TRC AGENDA

CITY OF DELAND
THURSDAY NOVEMBER 17, 2022 AT 1:30 P.M.
CITY OF DELAND TRC MEETING ROOM
DELAND, FLORIDA

Issues for record SP22-131
Job Address: 0 S Woodland BLVD,
Job Description: drive thru coffee shop

City of DeLand
TRC
SP22-215
NOVEMBER 17, 2022

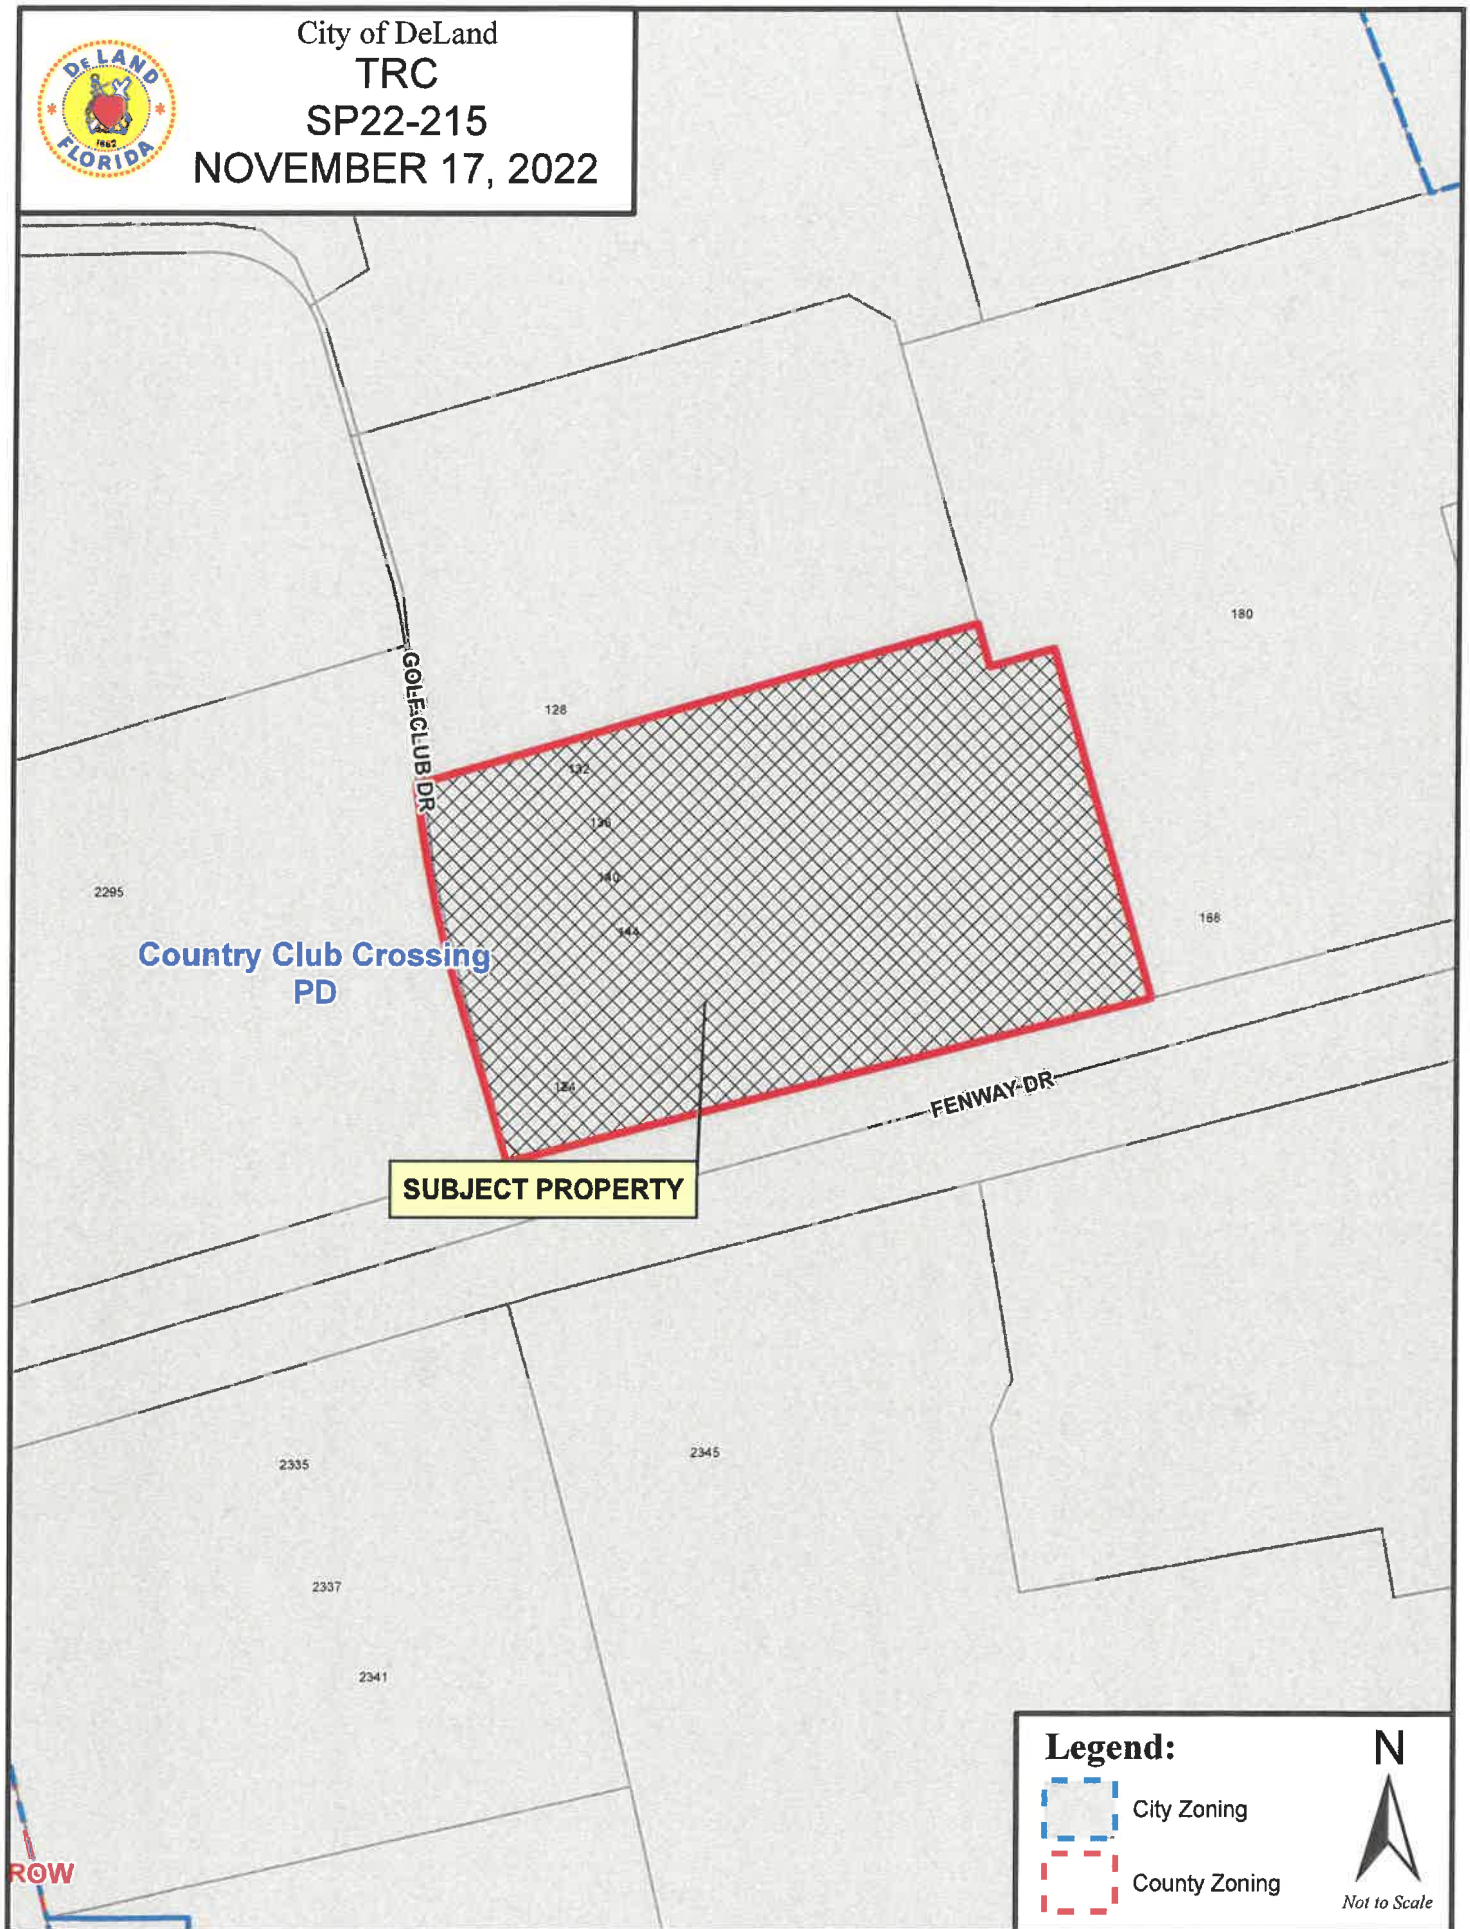
Discipline	Status	Details	Attached To	Created By	Last Updated By	Modifications Required
General Comments						
Engineering	Draft	1. Please provide a copy of the approved SJRWMD permit or letter modification upon issuance. This is required before scheduling the pre-construction meeting.		Tuan Huynh	Tuan Huynh	Yes
Dumpster Location						
Engineering	Draft	1. Can dumpster be rotated slightly so that back-in and back-out truck maneuvers will not hit the Type 'D' curb in front of dumpster? Please provide min. 50 feet clearance for this maneuver.	C-301	Tuan Huynh	Tuan Huynh	Yes
Adjacent Development						
Engineering	Draft	1. The adjacent vacant lot to north has submitted plans (SP21-093) for proposed Primary Care Clinic. Please ensure that this development grading will match the proposed clinic grading plan and the drainage between the lots will not be blocked or impeded. Please note that the tie-down slopes between the two parcels must not exceed 4:1 (H:V).	C-401	Tuan Huynh	Tuan Huynh	Yes

Asphalt Pavement Detail						
Engineering	Draft	1. Should pavement base say 6" Crushed Concrete or Limerock?	C-401	Tuan Huynh	Tuan Huynh	Yes
Pavement Grading and Runoff Ponding						
Engineering	Draft	1. Storm manhole A-20 has rim elevation (pavement grade) of 48.90. But grading plan shows flow arrows draining to Inlet A-10, which has a higher grate elevation of 49.00. Will this cause runoff ponding near manhole A-20 along share access drive or should the manhole be converted to a ditch bottom inlet grate to capture runoff? 2. Runoff will be trapped at the south parking space with grade BC 49.00 due to downstream grade BC 49.20. Please provide positive drainage. 3. Will runoff be trapped east of the building along the drive aisle curb line grade BC 49.50? There is zero slope along the curb line at this location and grading plan does not provide centerline grades to ensure slope is directed to the middle of the drive aisle and toward Inlet A-30. Please ensure positive drainage.	C-401	Tuan Huynh	Tuan Huynh	Yes

Min. Pipe Slope						
Engineering	Draft	1. Storm pipe segment between Inlet A-40 to A-30 has a pipe slope of 0.10%. Per FDOT Storm Drain Handbook (2014), Table 4-1, for 18" pipe the min. physical slope should be 0.15% to produce a cleaning velocity of 2.5 feet/sec. Please revise pipe slope.	C-401	Tuan Huynh	Tuan Huynh	Yes

Discipline	Status	Details	Attached To	Created By	Last Updated By	Modifications Required
Perimeter Slope Tie-Down						
Engineering	Draft	1. Please show additional grades or contours around the perimeter to ensure that the tie-down slopes from proposed grades to existing grades do not exceed 4:1 (H:V) slope.	C-401	Tuan Huynh	Tuan Huynh	Yes
Pavement Marking						
Engineering	Draft	1. Provide 20 LF of double yellow striping at the stop bar locations to separate vehicular traffic. Callout striping per FDOT Standard Plans Index 711-001. 2. Provide a dimension min. 4 feet setback from stop bar to pedestrian crosswalk at Golf Club Drive.	C-301	Tuan Huynh	Tuan Huynh	Yes
Handicap Space Length						
Engineering	Draft	1. Handicap space are 20' x 12' (L x W) per City LDC, Chapter 33-91.06(b). Plans show 19' length.	C-301	Tuan Huynh	Tuan Huynh	Yes
Occupancy Classification						
Fire	Draft	In Summary property is listed as commercial. Fire Code will classify this project as Special Purpose Industrial. Fire protection may be required depending on storage and operations.		Terry Griffiths	Terry Griffiths	Yes

Fire Hydrants						
Fire	Draft	Provide fire hydrants within 1000 ft. Provide fire flow data within the last year.		Terry Griffiths	Terry Griffiths	Yes
Turning Radius						
Fire	Draft	Provide Auto turn with fire apparatus loaded in Attachments.		Terry Griffiths	Terry Griffiths	Yes
Site Map						
Fire	Draft	Site location is shown off Orange Blossom Trail. Wrong City.	C-101	Terry Griffiths	Terry Griffiths	Yes
Tree legend						
Forestry	Draft	Add palm trees to tree legend.	C-201	Mariellen Calabro	Mariellen Calabro	Yes
Tree Barricade and Planting Details						
Forestry	Draft	Add tree barricade and appropriate planting details here if they are not included in your landscape plan.	C-903	Mariellen Calabro	Mariellen Calabro	Yes

Discipline	Status	Details	Attached To	Created By	Last Updated By	Modifications Required
Forestry	Draft	Orange County Remove reference to Orange County.	C-101	Mariellen Calabro	Mariellen Calabro	Yes
Insufficient Tree Information Provided						
Forestry	Draft	Please provide tree survey, landscape plan, tree worksheets, tree barricade detail, and irrigation plan. If any Tree Protection Area is on this parcel, please show it on the plan. Sufficient landscaping must be provided per the Country Club Corners PD and mitigation plan.	C-101	Mariellen Calabro	Mariellen Calabro	Yes
Tree Removals and Replacement						
Forestry	Draft	Will any additional trees be removed as part of this project?		Mariellen Calabro	Mariellen Calabro	Yes
Building Use						
Planning	Draft	Please list the use of the building (Auto Service). You have the zoning listed as the proposed land use.		Danevsky Joseph	Danevsky Joseph	Yes
Sign

Planning	Draft	How big will the monument sign be?		Danevsky Joseph	Danevsky Joseph	Yes
33-19.06. Automobile service stations.						
Planning	Draft	33-19.06. Automobile service stations. (b)Curb breaks. The number of curb breaks for one establishment shall not exceed two for each 100 feet of street frontage, each having a width of not more than 30 feet and located not closer than 15 feet from a street intersection.		Danevsky Joseph	Danevsky Joseph	Yes
Water Note 3						
Utilities	Draft	Replace with city.	C-501	Jim Ailes	Jim Ailes	Yes
Wrong Info						
Utilities	Draft	1101 S. Amelia Ave DeLand FL 32724 386-626-7250	C-101	Jim Ailes	Jim Ailes	Yes

Discipline	Status	Details	Attached To	Created By	Last Updated By	Modifications Required
City Details						
Utilities	Draft	These are not the current city of DeLand Utility Details, the most current details are on the city website and are dated 11/5/21. Please add sewer details and all of the potable water details please.	C-903	Scott Zender	Scott Zender	Yes
Sewer Note						
Utilities	Draft	Replace works with utilities	C-501	Jim Ailes	Jim Ailes	Yes

City of DeLand
TRC
FSB22-218
NOVEMBER 17, 2022

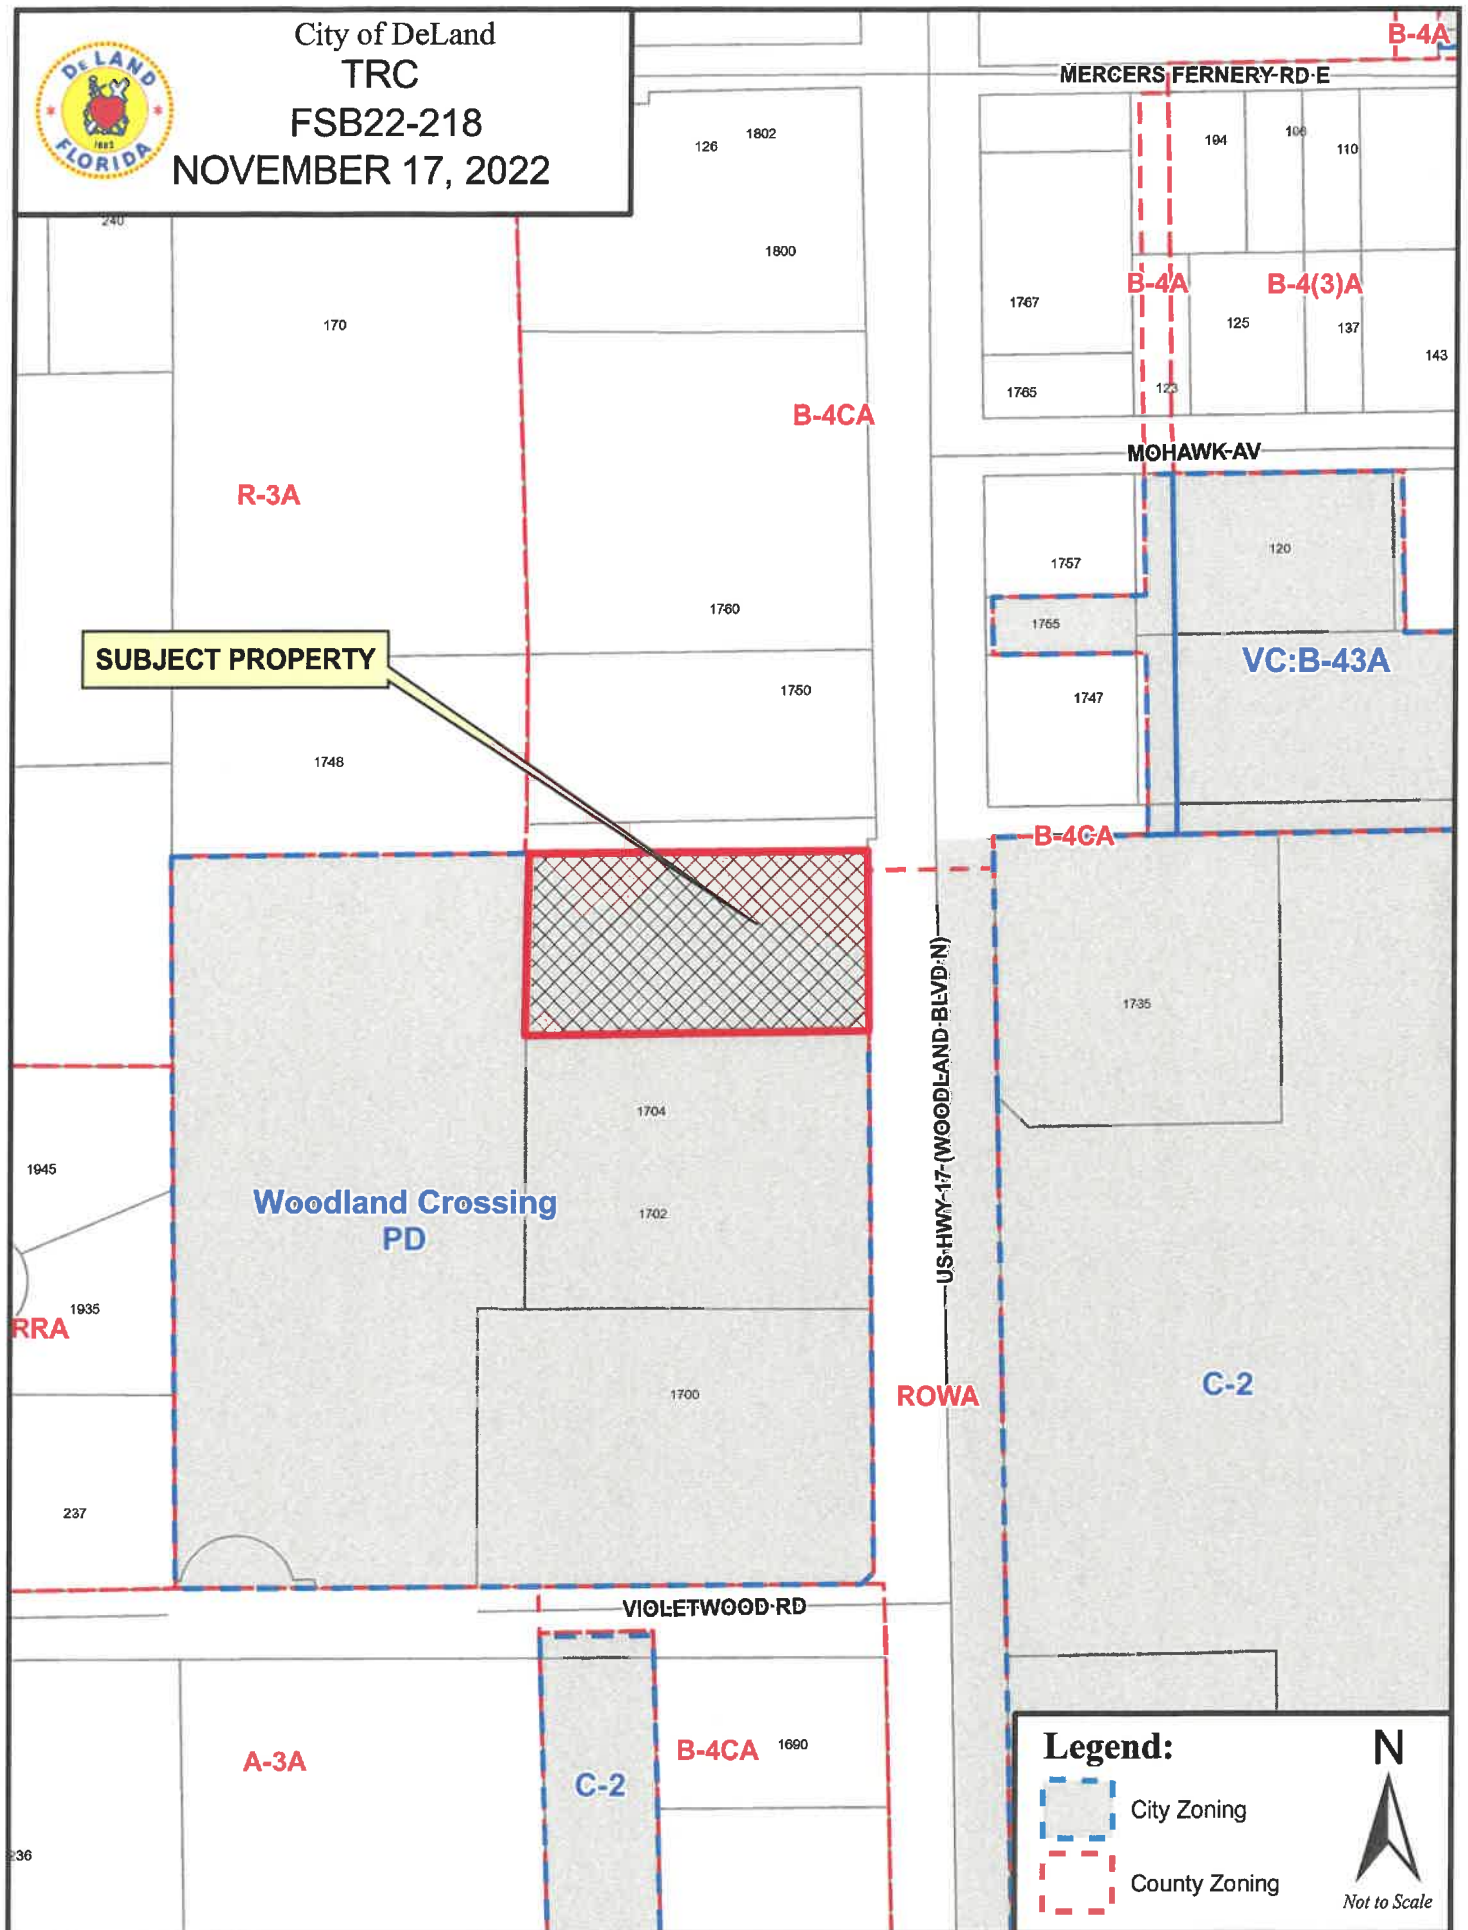
Discipline	Status	Details	Attached To	Created By	Last Updated By	Modifications Required
Fire	Draft	Access Easement If this area is for future entrance or exit, it needs to be at least 20 ft.	PLAT 2	Jamie Lunsford	Jamie Lunsford	Yes
Forestry	Draft	Tree Protection Area Change Tree Protection Easement to Tree Protection Area to remain consistent with Code language.	PLAT 2	Mariellen Calabro	Mariellen Calabro	Yes
Planning	Draft	Provide Title Opinion Provide Title Opinion		Kendall Story	Kendall Story	Yes
Planning	Draft	10' Gap Why is there a 10' gap in the TPA adjacent to Woodland?	PLAT 2	Kendall Story	Kendall Story	Yes
Planning	Draft	Emergency Access Is the 16' labeled at the northeast corner of Lot 2 for emergency access? If yes, must be 20' min.	PLAT 2	Kendall Story	Kendall Story	Yes
Planning	Draft	Access Easement The easement labeled Access Easement to Lot 4 should include Lot 2 as well.	PLAT 2	Kendall Story	Kendall Story	Yes

Planning	Draft	TPA 15% Does the TPA for Lot 2 = 15% of Lot 2? Does the remainder of the subdivision have 15% TPA or more remaining?	PLAT 2	Kendall Story	Kendall Story	Yes

Discipline	Status	Details	Attached To	Created By	Last Updated By	Modifications Required
BSL						
Planning	Draft	Remove "Building Setback Requirements" from bottom of sheet 2 Also remove all references to the BSL on the plat. We do not want to record building setbacks on the plat.	PLAT 2	Kendall Story	Kendall Story	Yes
TPA Roster by lot						
Planning	Draft	In table format, provide a TPA "roster" for each lot. Individually/Total: • Current TPA area, per lot • Proposed TPA area, per lot	PLAT 2	Kendall Story	Kendall Story	Yes
